Reply to TAC's comments
on proposal P12-10-009 to Jefferson Lab PAC35

**PR12-10-009 Search for a New Vector Boson A'
Decaying to e^+e^-**

from R. Essig, P. Schuster, N. Toro, B. Wojtsekhowski (contact person)

January 24, 2010

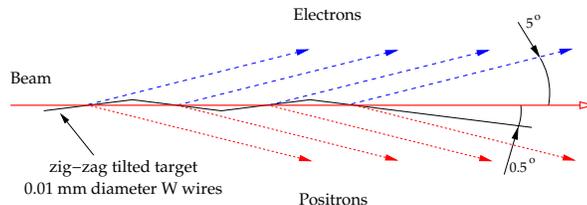
The zig-zag mesh design of the tungsten target significantly reduces the multiple scattering, which is critical for this measurement. It is a challenging design. Only limited details are presented in the proposal and some parameters are given in ranges (how many zig-zag plane: 4-5? length: 5-10 cm? radiation length: 0.5-10%? wire spacing: 0.15 to 0.5 mm?). Are they corresponding to different energy settings (in this case, it should state clearly which configuration corresponding to which setting). Due to the tight requirements in resolution, angle and available space, these details are needed to evaluate the possible issues. For example, if one plane length is 5 cm tilted at 10 mr, 0.5-mm rastered beam will reach the edge of the mesh plane. The events near the edge can not be distinguished from the events hit the adjacent mesh plane and this leads to worse resolution. This will affect the stated 5-cm target vertex correlation between arms and affect the quoted additional accidental background rejection factor of 4 from vertex reconstruction. Another question is how to vary the spacing of wires: Are they different targets? Since on page 28 it stated only one target, do we need to change target for different energies? It probably is easier just to have multi targets on the ladder (need to design cooling accordingly).

While the conceptual target design is provided in the proposal, the proposal did not include a complete design, as many of the detailed aspects do not impact the reach of the experiment. The final specifications of the design described in the proposal will be finalized at a later date. Below, we describe in more detail aspects of the design that do impact reach, respond to the above comments, and review the precise configurations used in calculating the reach of the experiment as shown in the proposal.

We refer the reader to Figures 1 and 2 that describe the target. Figure 2 is new and was not included in the proposal. The properties of the target design that lead to an excellent mass resolution, good vertex resolution (optics), and sufficient cooling are:

- Multiple scattering from outgoing e^+e^- pairs (in particular those originating from an A' decay inside the material) must be small so as to not degrade the mass resolution. This is achieved by using wires (Tungsten) strung together to form a plane, see Figure 2. The radius of each wire is about 5–15 μm , and the spacing between the wires is sufficiently large that an e^+e^- pair coming from a prompt A' decay inside a wire misses the next wire. For example, for $m_{A'} \sim 0.2$ GeV and $E_{\text{beam}} \sim 3.3$ GeV, the typical angle of the outgoing e^+e^- pair is $\sim 0.2/3 \sim 0.06$ rad. The e^+e^- pair will miss the next wire if the wire spacing is at least $10 \mu\text{m}/\sin \theta_e \sim 165 \mu\text{m}$ (assuming a $\sim 10 \mu\text{m}$ radius wire). Smaller e^+e^- angles are obtained for lower A' masses and higher beam energies, but for the suggested run plan we never want the spacings between the wires to be less than $\sim 200 \mu\text{m}$, and in practice they can be a factor of a few larger without affecting the reach. Note that a target foil would have worse mass

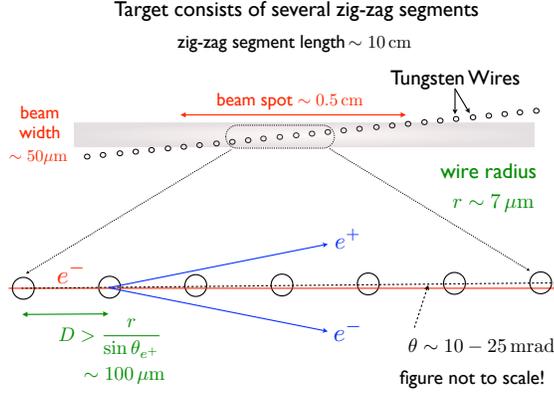
Wire-mesh with spacing will lead to non-uniform target thickness pattern at the micro level (coupled with raster frequency). The effect of the non-uniformity on the accidental suppression using coincidence time should be evaluated.

We would like to emphasize that individual target planes are designed and angled in such a way that each beam electron passes through several wires (~ 15 wires, depending on their separation). This can be done while allowing for the outgoing e^+e^- pairs to traverse only one wire. This means that the fractional variation of the target thickness along the transverse direction of the beam line (along the rastering directions) is at most $\sim 5\%$. Figure 2, shown in reply to TAC comment 5, illustrates this in more detail.
